Memorandum

Re: Congregation Bais Levi Yitzchok, 130 Camp Hill Road
SBL# 25.17-3-30

Date: July 12, 2023

Plan Set
Sheet 1 of 10

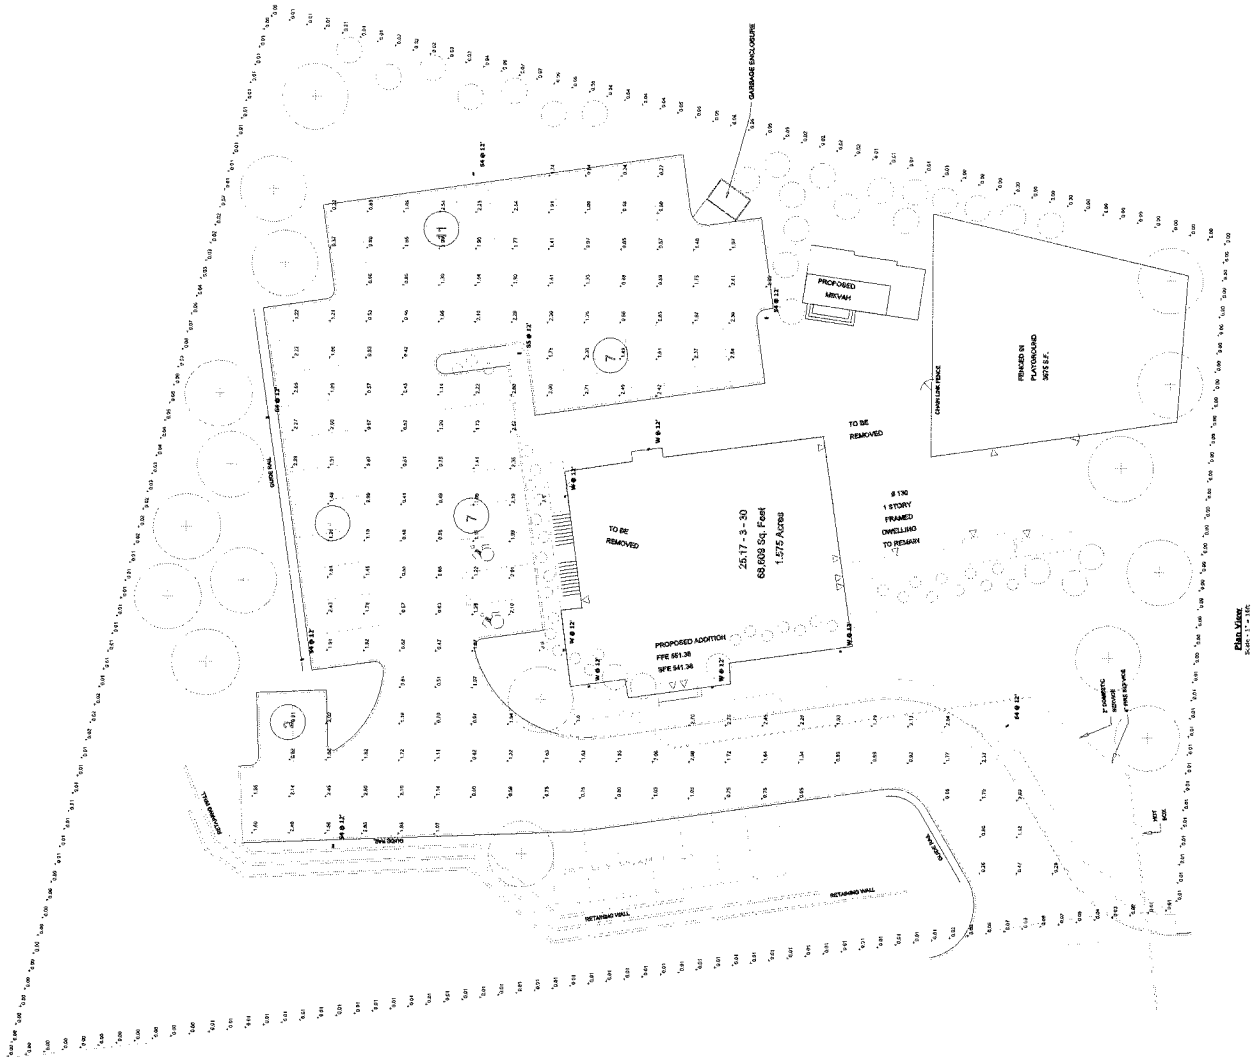
1. **Please renumber the eight site plan sheet drawings consecutively.**
2. The lighting plan has been updated; however, the sheet is still dated 4/28/23. **Please indicate the latest revision date on the lighting sheet. Please provide a detail of the proposed lamp posts and manufacturer's cut sheets on the proposed light fixtures and luminaires. The lighting plan now indicates lower 12-foot light posts and wall mountings at 12 feet, but the value 10 feet appears in the schedule table. Also, the lighting plan still shows 7 overflow parking spaces in the front of the building which have been eliminated on all the other sheets. Please clarify the discrepancies and add requested details to the lighting sheet.**

6. See comment 2 above regarding the provision of light pole and fixture details. The lighting plan has been revised so that the maximum illumination level at the property lines is 0.1-foot candles or less which is in compliance with §130-10.H.(7).
